Amphenol PCD

Engineering Change Request		ECR Number	R10544W
Initiator:	Tom	Date:	26.8.31
Part number description			
Item	K3 Code material part numbers	Note	
1	HVCON1 Series AC plug	Detailed model information see the attachment	
2	HVCON1&2 Series DC plug	Detailed model information see the attachment	
Reason of change:			
☐ Customer requirement (list the feasibility analysis of customer specification: _____)			
☐ Supplier request (list the PCR number: _____)			
☒ internal improvement ☐ corrective ☐ other			
Please describe here in detail:			
<u>ITEM1-2. Improve product waterproof performance.</u>			
Change level and impact assessment (Please tick in the appropriate position)			
Change level	Change content	Concerned area (Shenzhen, Hermosillo, Chennai)	Whether to notify the customer
Level 1	☐ Operator change		☐ It is not necessary to notify the customer for approval
	☐ Correct the clerical errors of the drawing, BOM, etc., and this change will not affect the production process

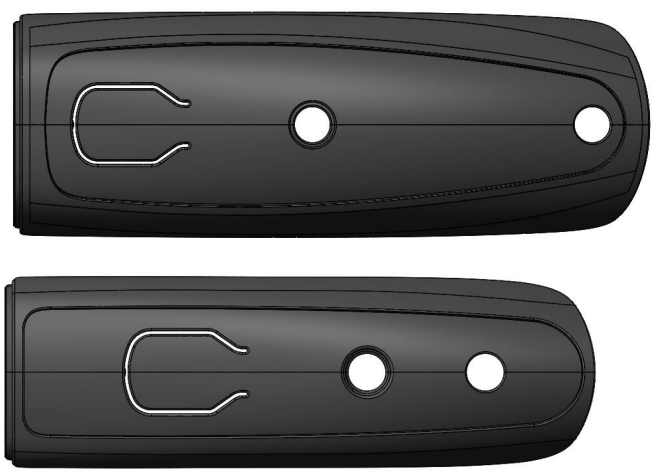
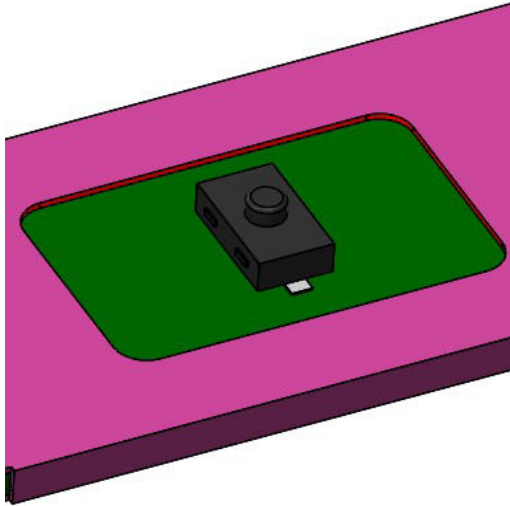
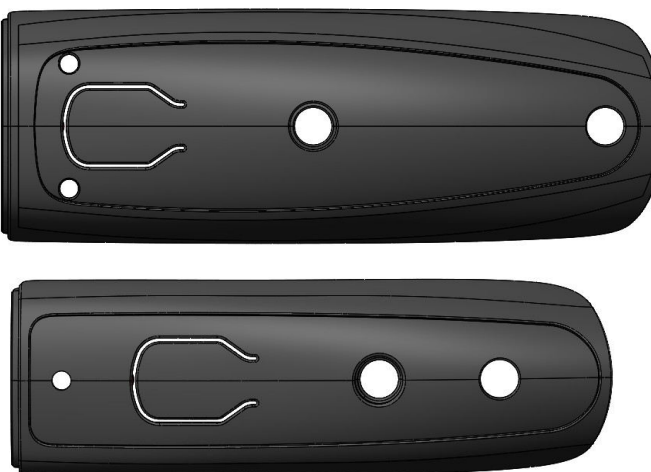
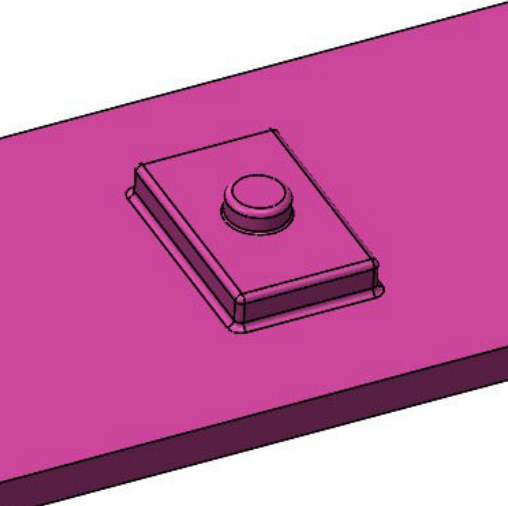
Before change ITEM1-2.  		After change ITEM1-2.   Adding small holes and switch protective covers improves the product's waterproof performance.			
Disposition of old materials ☐ Rework ☒ Use as it is ☐ scrap ☐ Other (please describe): _____. ☐ N/A		Expect date to switch to new material Sep 2026			
Approval by the supervisor of requester.: rock.chen Derek		Approval by the head manager of the request dept.: zhong			
Customer approval: ☐ Approved ☐ No approved ☐ Conditional approval (please describe) : Signature: Date:					
Remark:
